HISTORIC AND DESIGN REVIEW COMMISSION

September 20, 2017

HDRC CASE NO: 2017-066
ADDRESS: 2450 ROOSEVELT AVE
LEGAL DESCRIPTION: NCB 7456 BLK PT OF DIV 2 OR PT OF TR A 5 39 AC
ZONING: I-1, RIO-5
CITY COUNCIL DIST.: 3
APPLICANT: Jim Bailey/Alamo Architects
OWNER: James Lifshutz
TYPE OF WORK: Exterior modifications, creation of additional window openings
REQUEST:

2450 ROOSEVELT AVE

WEST ELEVATION

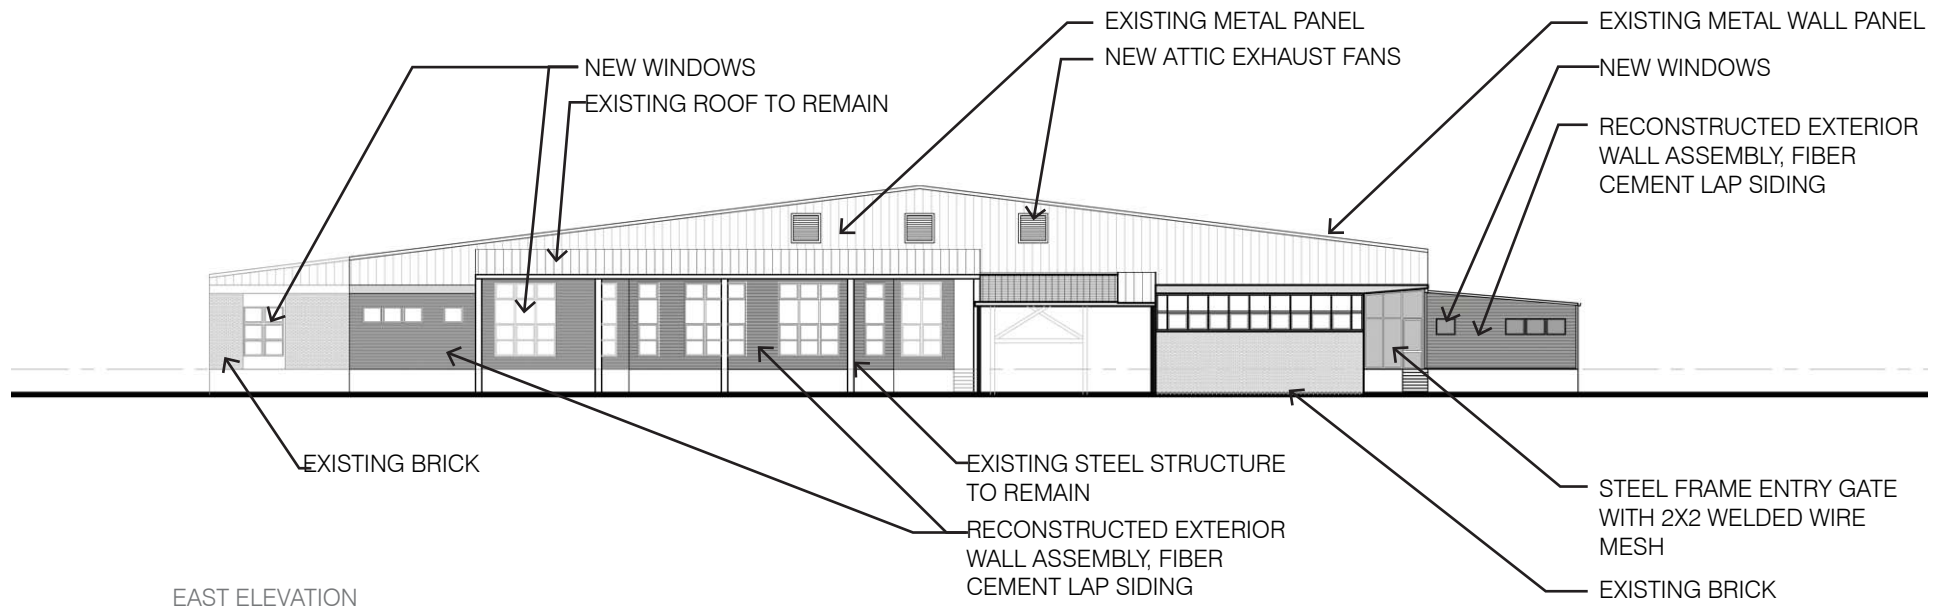
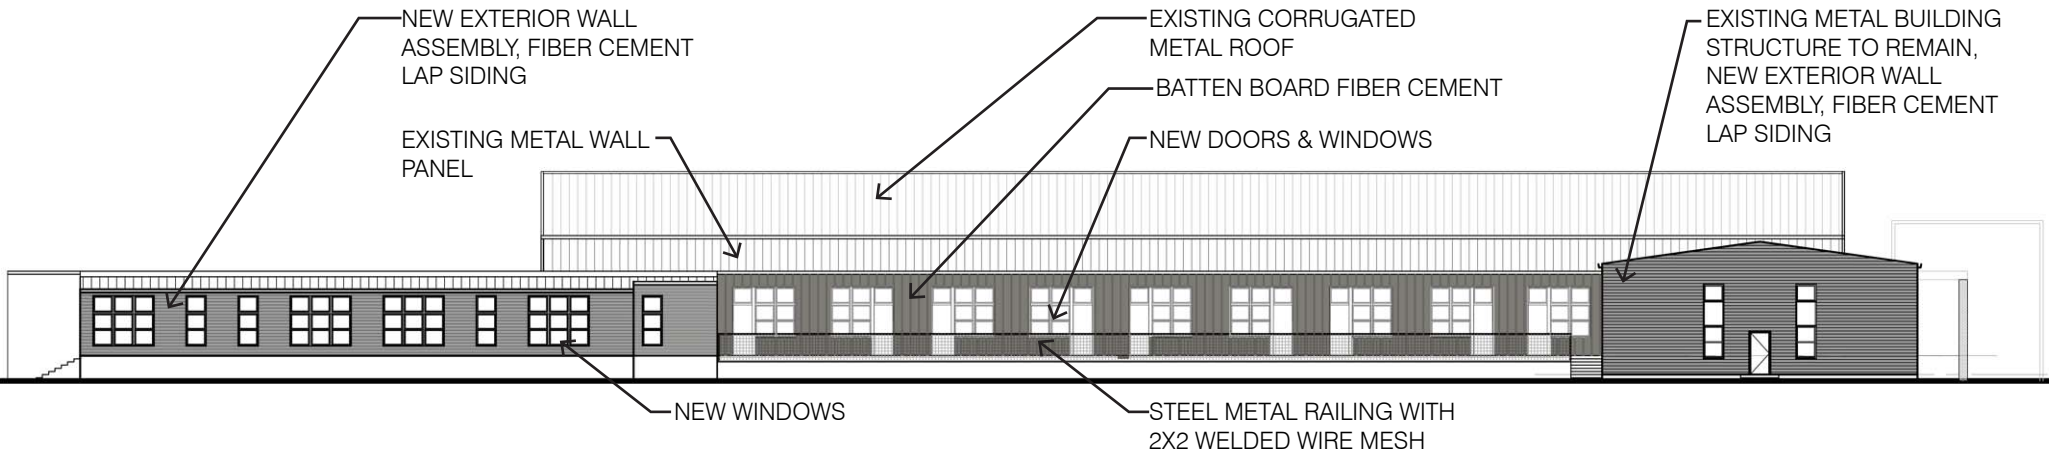
- e. FAÇADE MODIFICATIONS – The applicant has proposed to create new façade openings on the Roosevelt façade to match those currently existing on that façade. The proposed openings are to match those currently in existence. Staff finds this appropriate and consistent with the UDC Section 35-674.

Staff recommends approval based on findings a through g with the stipulation that all parking feature a buffer from the public right of way and that the proposed development meet the required landscaping standards noted in the UDC section 35-672 and 35-673.
